Product Change Notice (PCN)

PCN Number: **PCN-0451088R-01**

Product(s) Affected: **PJ-040-SMT-TR**

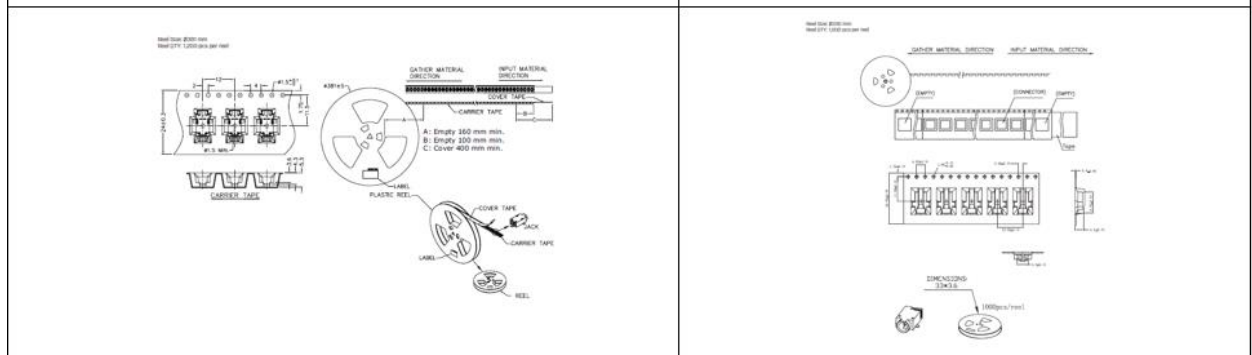
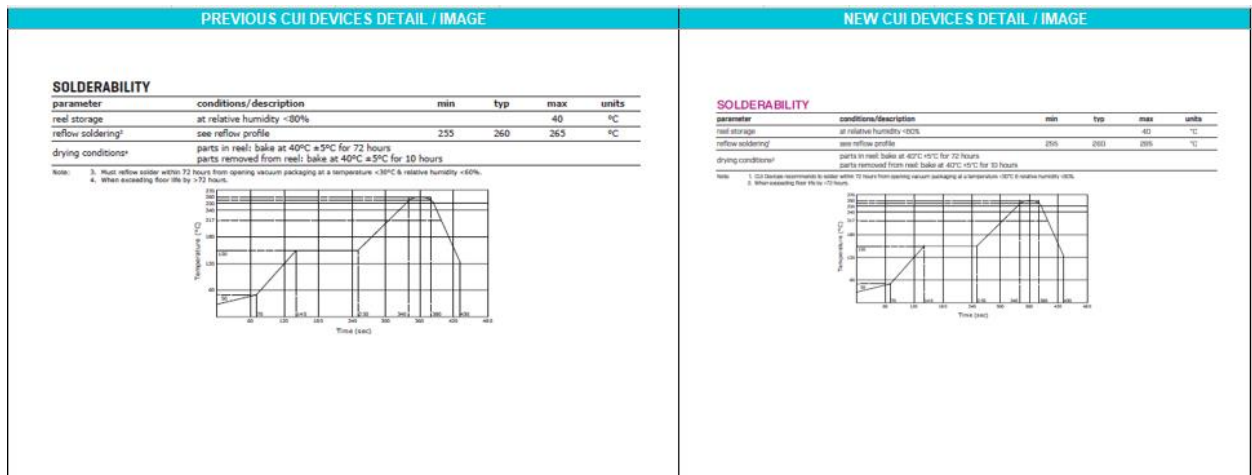
Description of Change: **Minor Housing and footprint differences. Material Change on the housing and terminals. See image Below**

MATERIAL	PLATING
center pin	copper	nickel
terminal 1	brass	silver
terminal 2	copper alloy	silver
terminal 3	copper alloy	silver
plastic	PA6T or equivalent

DESCRIPTION	MATERIAL	PLATING/COLOR
center pin	bronze	silver
terminal 1	bronze	silver
terminal 2	SUS301 t-0.20 mm	gold
terminal 3	SUS301 t-0.20 mm	gold
housing	PA10T (UL94V-0)	black
